What changed, and why these drawings are different

Corrections to the architectural brief

- 1 Drawing set, corrections and measured areas
- 2 Ground floor, target operating state
- 3 First floor, target operating state
- 4 Ground floor, access and flow
- 5 First floor, access and flow
- 6 Ground floor, demolition and new work
- 7 First floor, demolition and new work

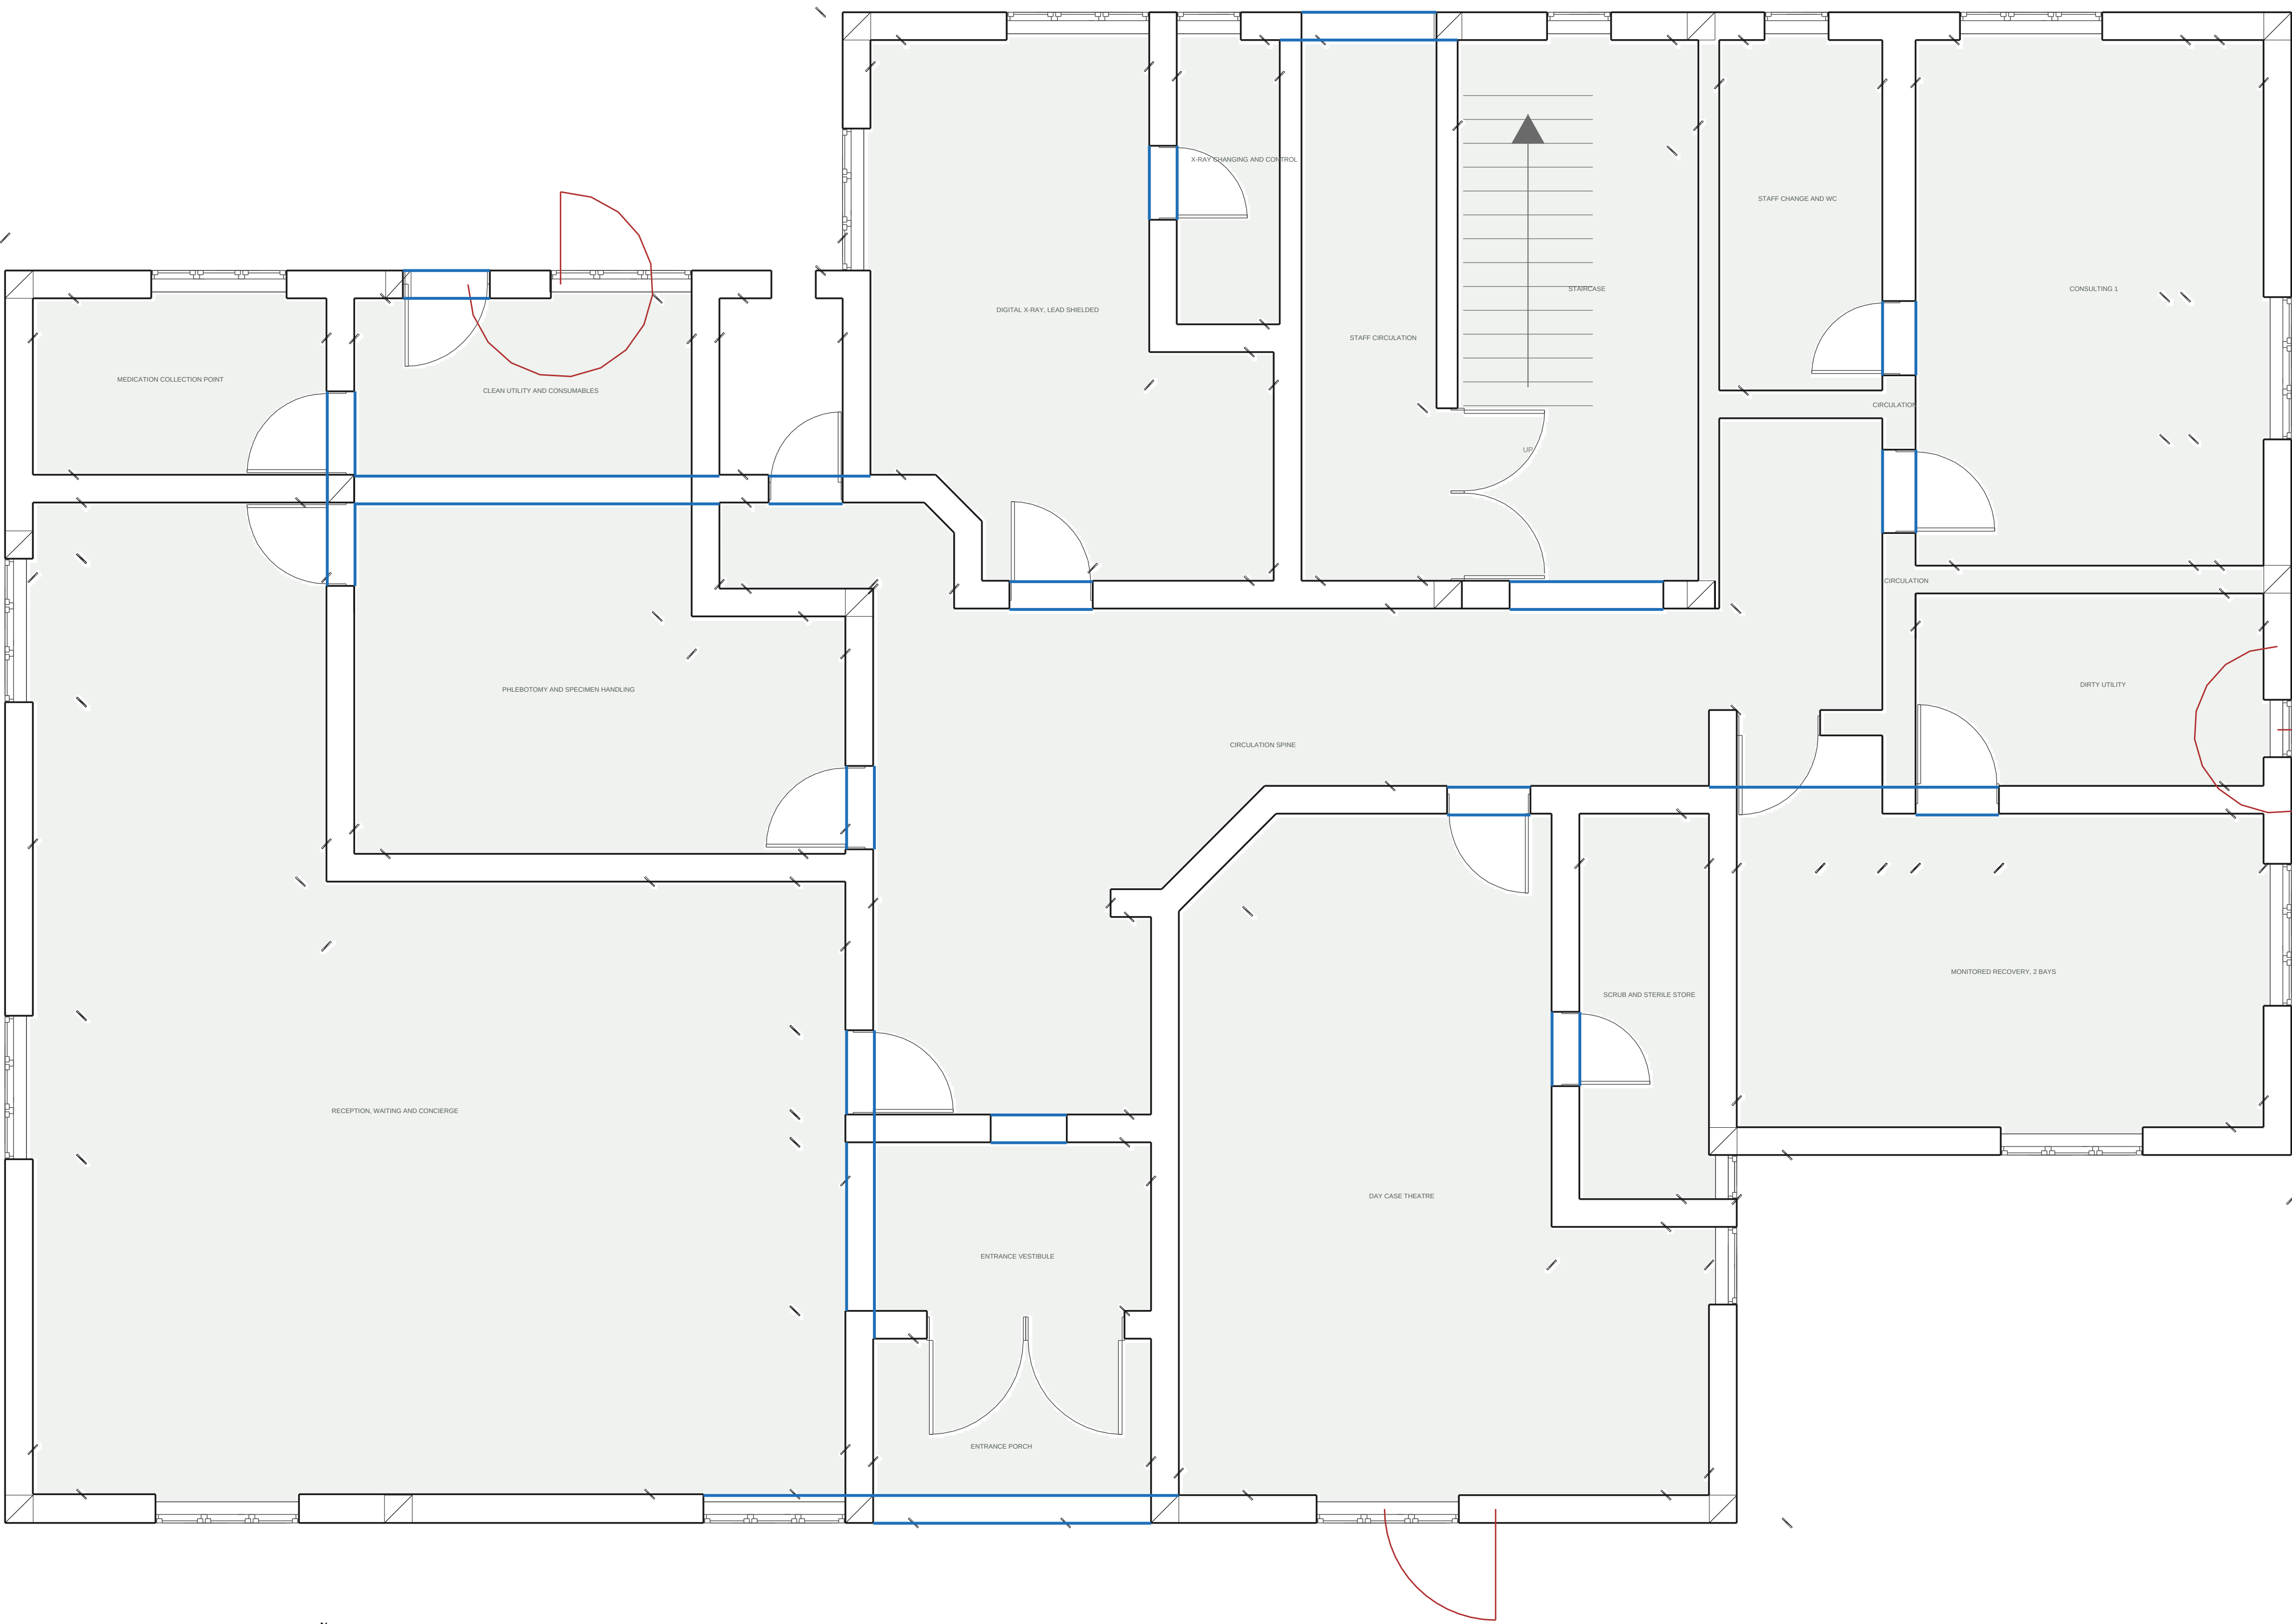
- ## **RULES THE DRAWING MUST KEEP**
- The specimen route must not cross the patient waiting hall.
 - The clinical waste route must not cross the patient or specimen routes.
 - Staff reach the lounge, sterilising and linen without passing through waiting.
 - One reception desk, one patient entrance. Do not draw a second.
 - The theatre suite has a single controlled entry off the spine. Nothing passes through it to reach anywhere else.

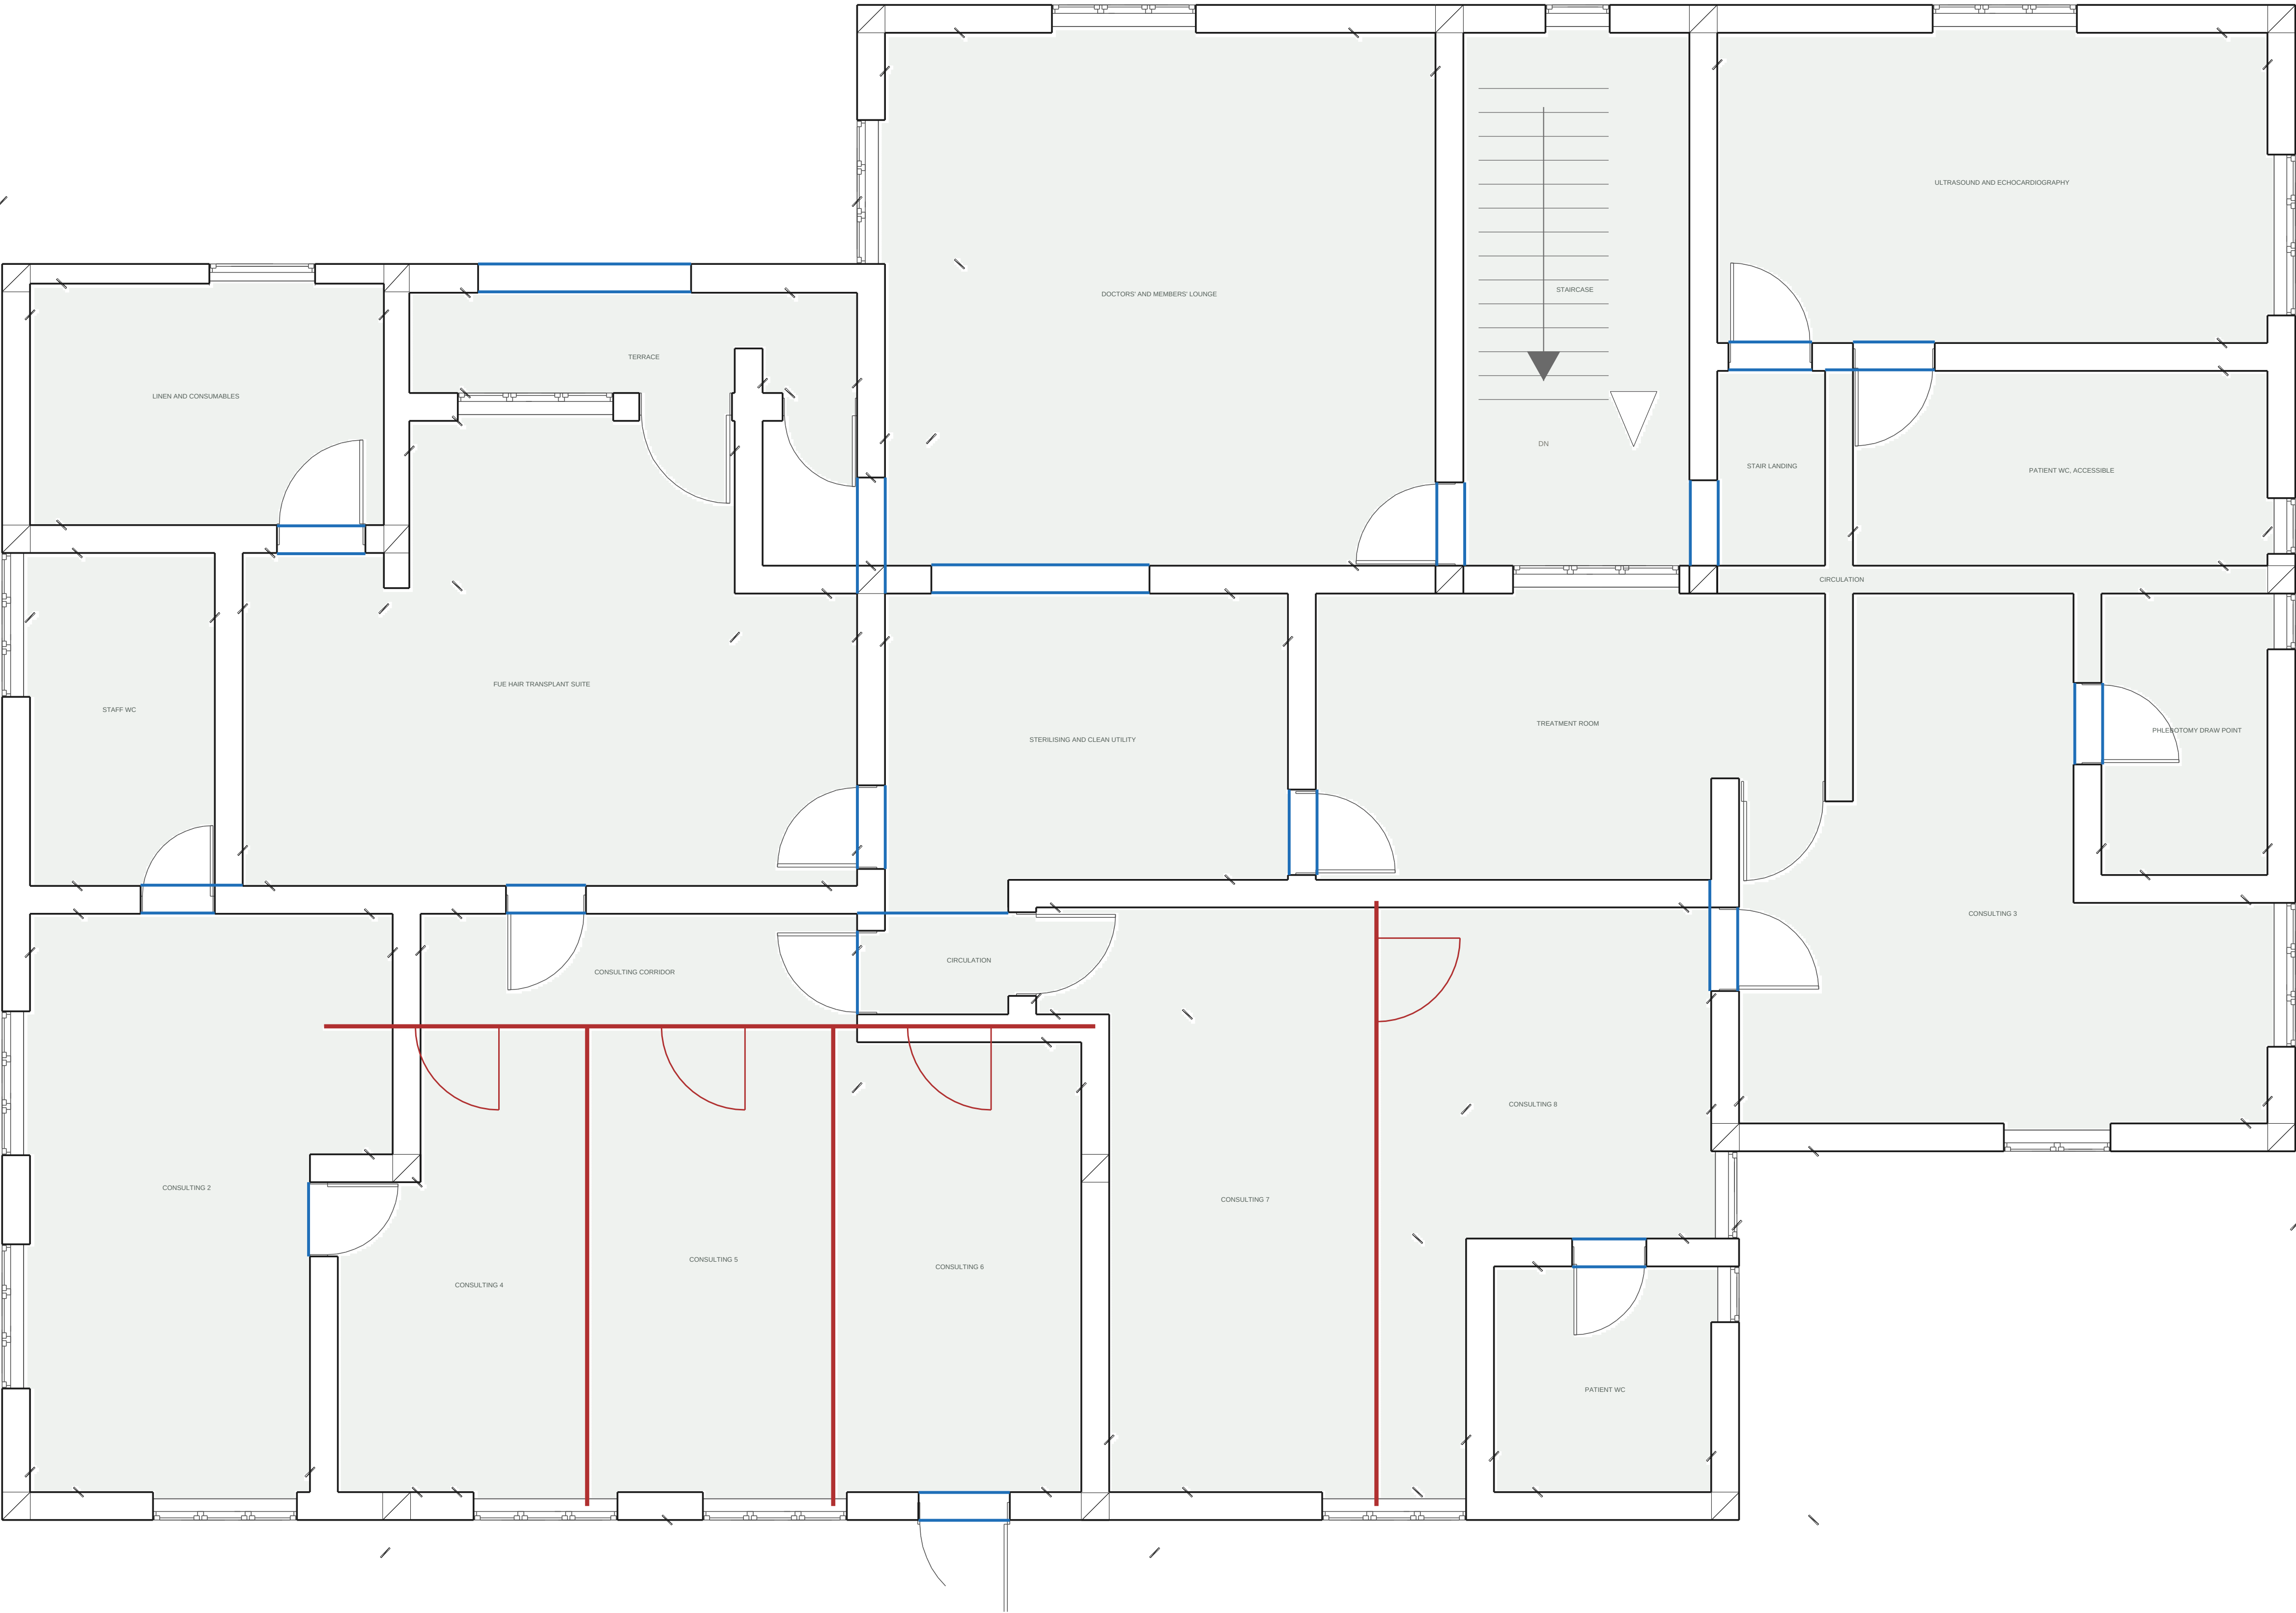
- No new partitions are needed on this floor. Every room in the target state is an existing room, which is why the ground floor can be fitted out first.
- The theatre suite is formed from four existing rooms that already adjoin: theatre, recovery, scrub and sterile store, dirty utility. Only the doors and the services change.
- The two waiting zones in the reception hall are divided by joinery, not a wall, so the single desk keeps sight of both.
